# Mission Grove Apartments Project

Final Environmental Impact Report  
SCH# 2022100610

**November 2024**

**Response 4.170:**

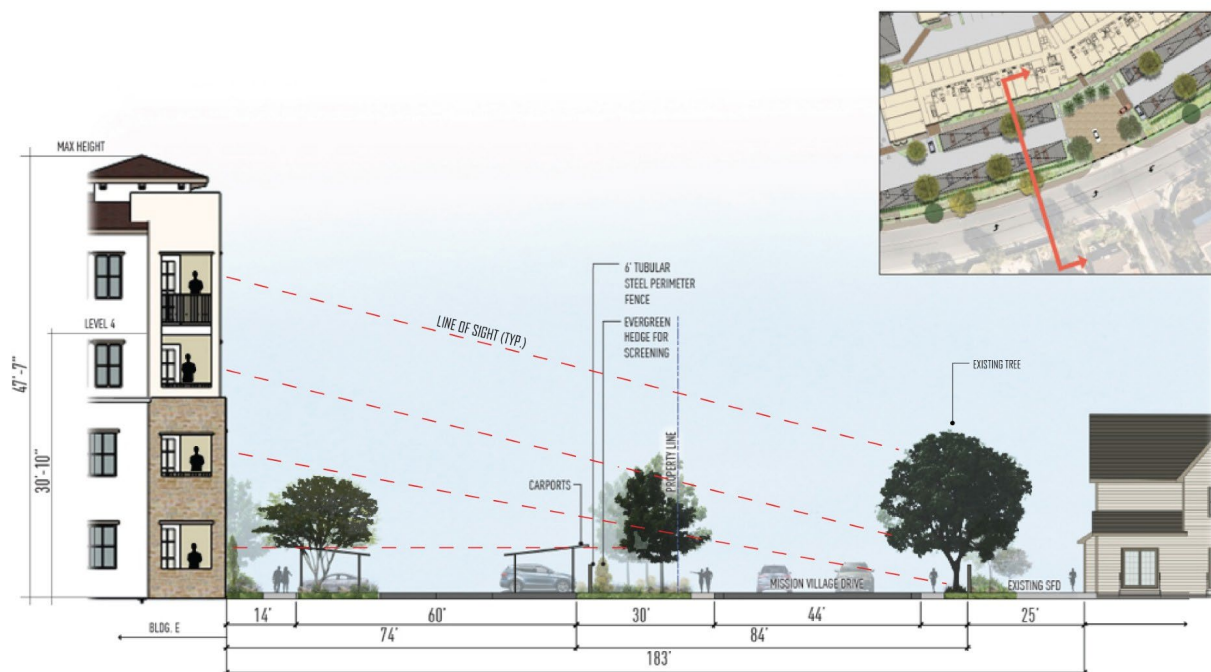
The commenter asks when architectural plans will be made available. Information regarding project plans (site plan, parking allocation plan, fire access plan, open space plan, floor plans, building elevations, colors and materials, conceptual landscape plans, wall and fence plans, photometric lighting plan, conceptual grading plans, tentative parcel map) was made available July 18<sup>th</sup>, 2024 on the City of Riverside Planning Commission website (<https://aquarius.riversideca.gov/clerkdb/DocView.aspx?dbid=0&id=362780&page=1&cr=1>) as part of the package submittal for review of the proposed Project at that Planning Commission meeting and remains available at that website. The commenter additionally asks if the apartment windows will overlook existing residences. The Project will not invade privacy laws and regulations as the existing residences will not be in view from the windows of the proposed buildings, as confirmed by the Project's architectural line of sight renderings.

As outlined in the rendering above, the closest apartment building and the closest single-family residence are located 183 feet apart and separated by Mission Village Drive. The line of sight between the apartment building and the nearby residences is broken up with the following: sidewalk, landscaping, parking, carports, fencing and evergreen hedge screening at the apartment development, trees within the landscaping buffer/setback on the north side of Mission Village Drive, Mission Village Drive, and a sidewalk, landscaping and block wall on the south side of Mission Village Drive. The distance between the apartment buildings and the nearest residences as well as trees, fencing and block wall reduce the visibility of the nearby single-family residences by the apartment tenants and vice versa.
